MEMORANDUM

SUBJECT: Zoning Text Amendment 19-08, Bicycle Parking – Requirements and Design Standards

PURPOSE: Worksession – recommendation to approve, amend, or disapprove

A bicycle room with appropriate parking space/aisle dimensions.

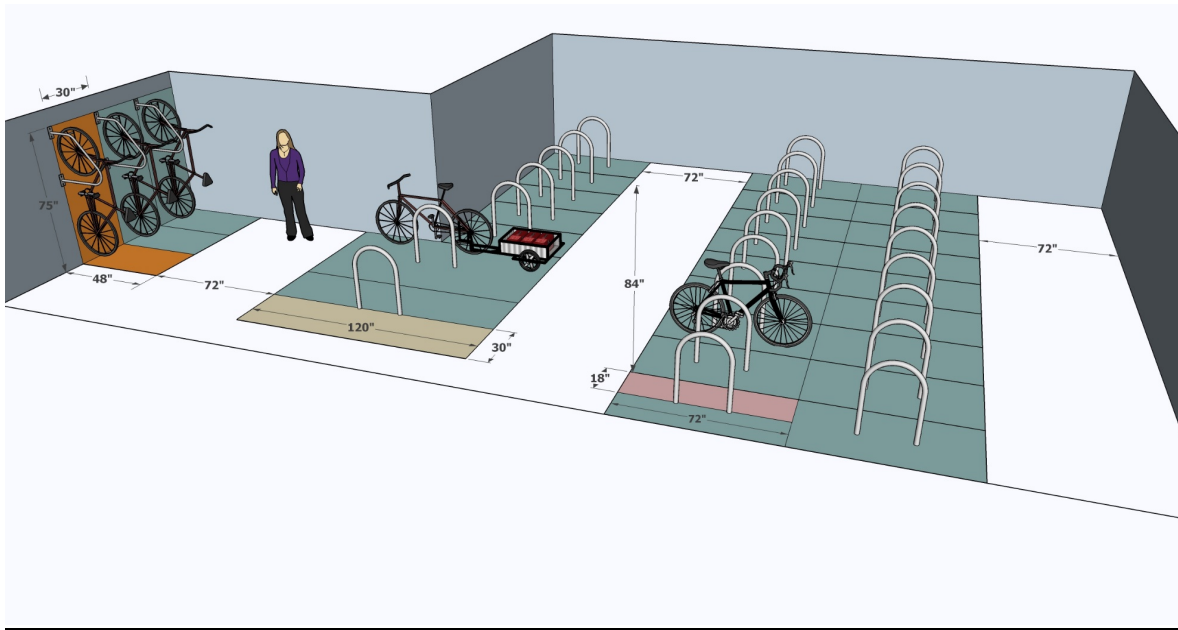
There was objection in testimony submitted to the Planning Board on increasing the dimension of the aisles in a storage room from 48 inches to 72 inches. Planning staff reported that this increased dimension was necessary and was offset by deleting the requirement for 48 inches along the perimeter of bike parking.

Comment: Aisle Width increase to 72". Please do not make this a requirement. 48" is sufficient if not optimal, and the additional width comes at a real cost (I calculate \$500 per bicycle in a double-loaded scenario – I'd rather go ahead and BUY the bicycle than pay for the space). Your guidelines could

Response: 48-inch-wide (4 feet) aisles are insufficient. A typical bike is 72 inches (6 feet) in length. Cargo bikes, which are increasing in popularity, are typically 96 inches (8 feet) in length. Accommodating larger bicycles, such as tandems and cargo bikes, were specifically called out in the Approved and Adopted Bicycle Master Plan. While we are increasing the space of each aisle, we are reducing the total number of aisles needed by deleting lines 143 to 145, which requires an additional 48-inch-wide aisle along the perimeter of the bike parking.
